Midway City Council  
3 March 2020  
Regular Meeting

Scotch Fields PUD /  
Master Plan Amendment

## CITY COUNCIL MEETING STAFF REPORT

**NAME OF PROJECT:** Scotch Fields Planned Unit Development

PROBST ENTERPRISES  
SCOTCH FIELDS PUD  
PHASING PLAN  
AMENDMENT

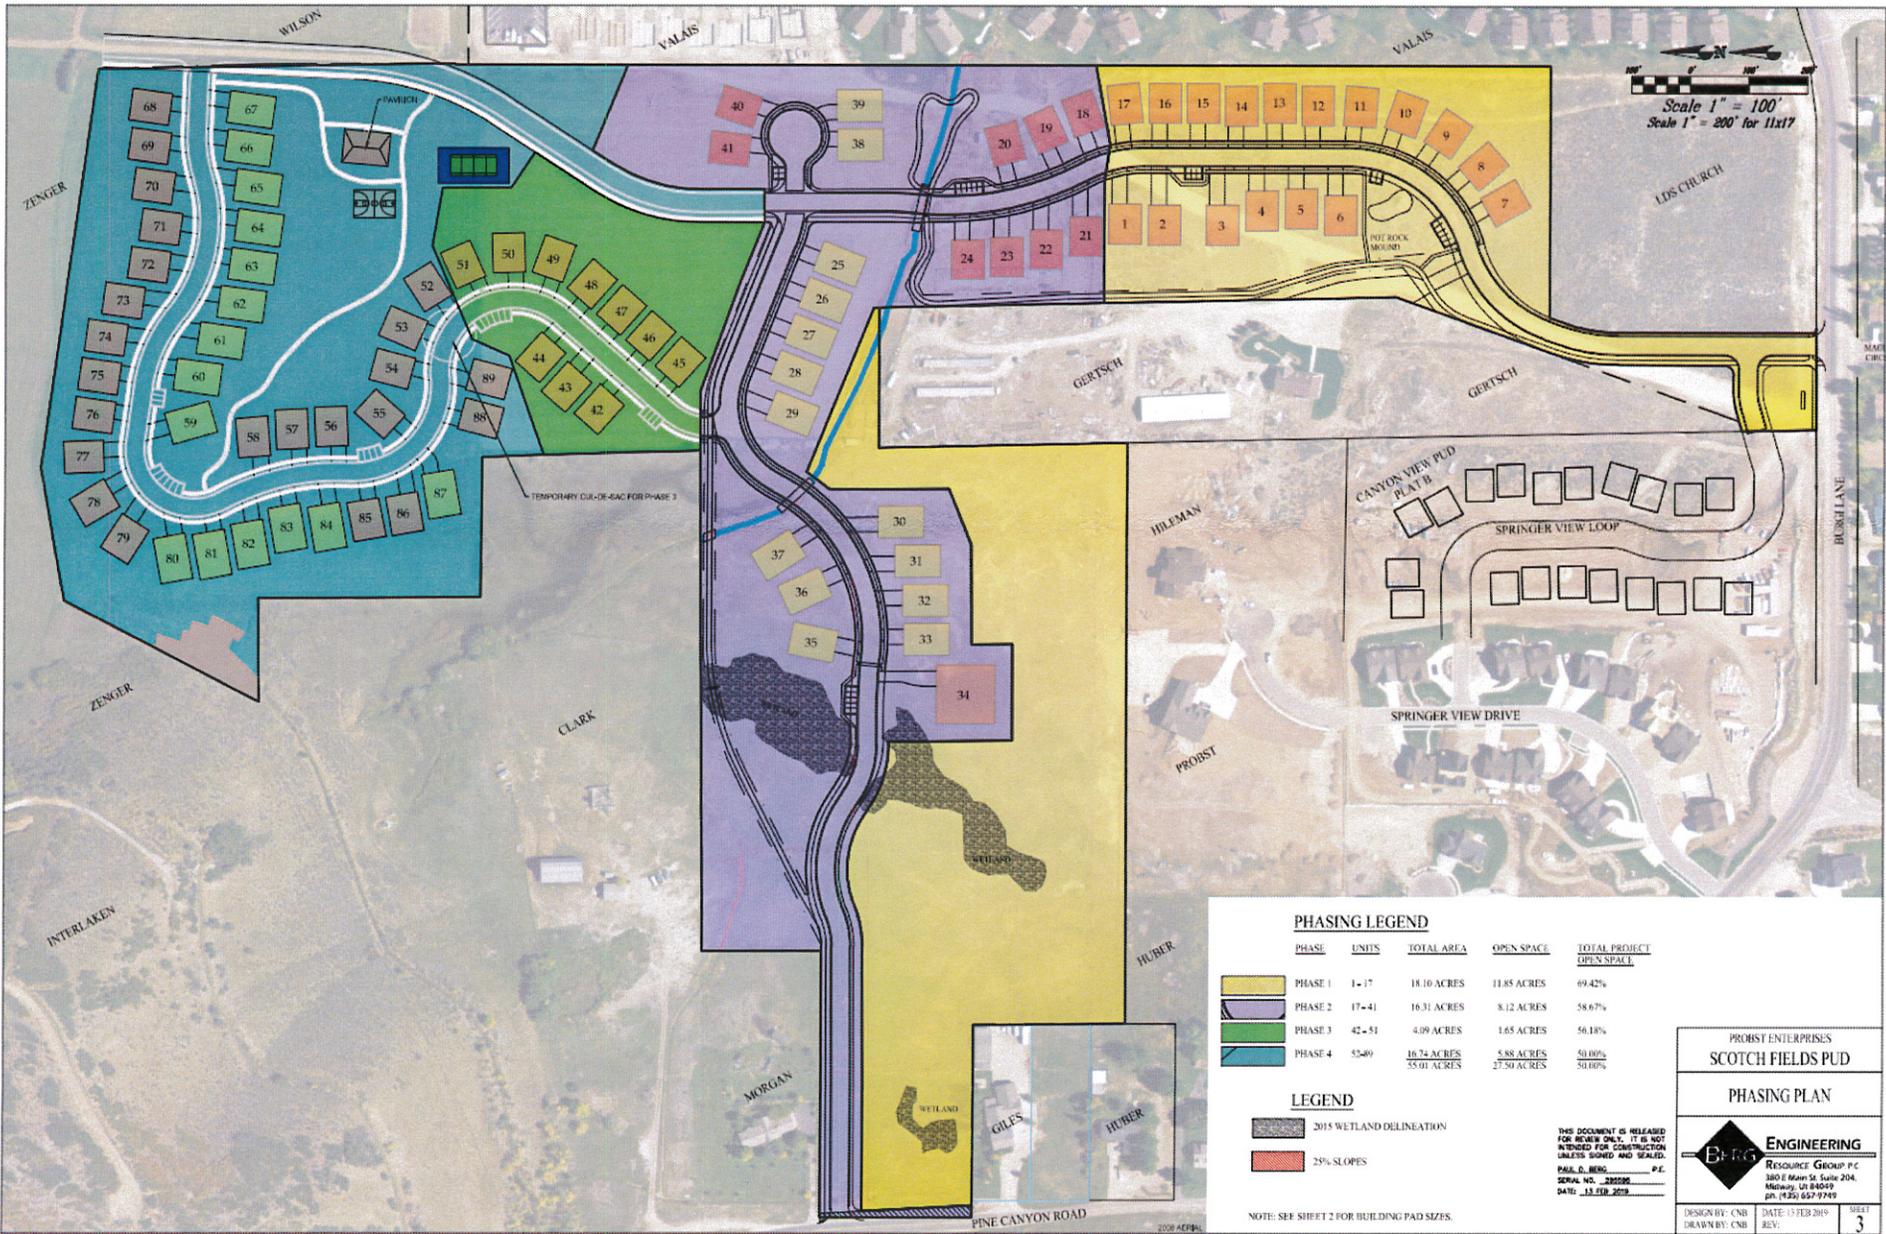
Phase 4, consisting of 37 units, received final approval on July 16, 2019. The proposal is to divide phase 4 into two phases. The newly proposed phase 4 would consist of 29 units and the newly proposed phase 5 would consist of eight units. The developer would be required to construct all infrastructure for both of the proposed phases as part of phase 4. That infrastructure includes Canyon View Road (public) and Jerry Gertsch Lane (private), storm drain system and ponds, water lines, and sewer lines.

Commissioner Bouwhuis stated that he did not like that having the one single island lot that is in the proposal

- The proposed master plan appears to meet the requirements of the code
- The number of phases will increase from four to five
- The proposed amendment does comply with current code requirements for phasing
- Amending the master plan is discretionary and the City is under no obligation to approve the proposal even if it complies with the land use code

PUD CONCEPT PLAN

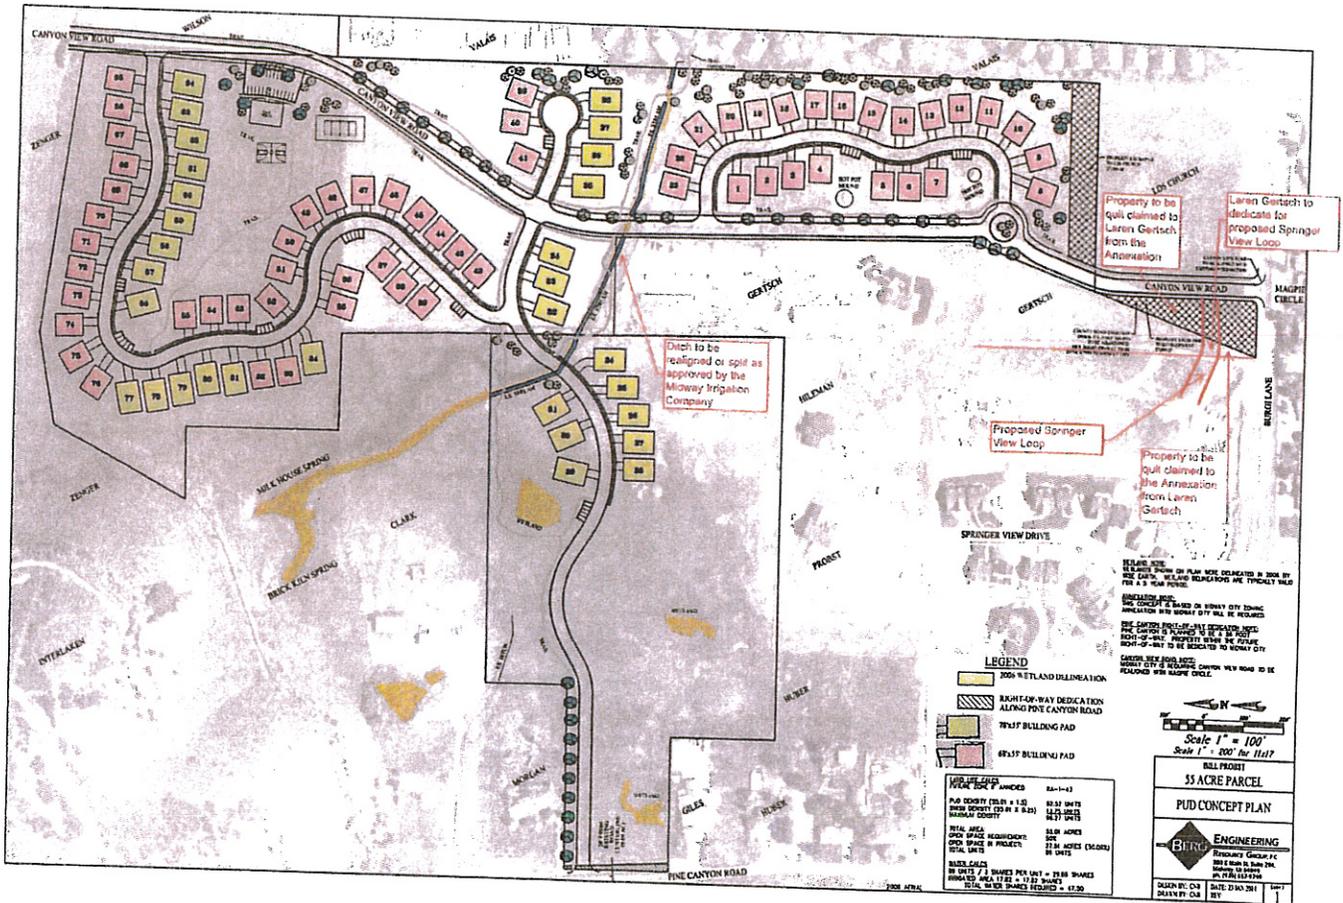
A meeting was held on Thursday, January 29, 2015 to discuss the proposed road intersection of Burgi Lane and Canyon View Road, relating to the proposed Canyon View Road Annexation. In attendance at the meeting were Michael Henke, Wes Johnson, representing Midway City (hereinafter called the "City") Bill Probst, Craig Probst, Dennis Higley, representing the Canyon View Road Annexation and future Development, (hereinafter called the "Annexation"), Laren Gertsch, representing his property, and Troy Naylor, representing Canyon View PUD Plat B (hereinafter called the "PUD Plat B"). The following items were discussed and agreed upon. For reference, please see annotations made during the meeting on the attached concept plan illustration.

After a property exchange between the Annexation and the LDS Church, the centerline of the Canyon View Road will be realigned to match the existing centerline of Magpie Circle. The property exchange will be executed prior to any phase within the Annexation receiving Preliminary Approval *from City Council* (bold comment added 2-9-2015).

Springer View Loop, which is the proposed road within the currently plated PUD Plat B will extend to the East and connect into the realigned Canyon View Road. The centerline of Springer View Loop will be approximately 150 feet north of the existing centerline of Burgi Lane. The proposed roadway will not encroach on the existing pot rock mound located just south of the existing yard hydrant.

Laren Gertsch will quit claim to the Annexation a 50-foot strip of ground for the proposed Springer View Loop. The Annexation and a future plat will provide the right-of-way for the extension of Springer View Loop.

Any property which is currently South of the proposed Springer View Loop right-of-way line will be quit claimed from Laren Gertsch to the Annexation. The Annexation will grant to Laren Gertsch a utility easement for all existing utilities within the property.

The parcel of land, which will be exchanged between the Annexation and the LDS Church that is north of the Springer View Loop right-of-way line, and west the newly realigned Canyon View Road will be quit claimed from the Annexation to Laren Gertsch.

The existing ditch which is within and near the Laren Gertsch north property line will be split or relocated to provide water access along the north property line of the Gertsch property, as approved by the Midway Irrigation Company.
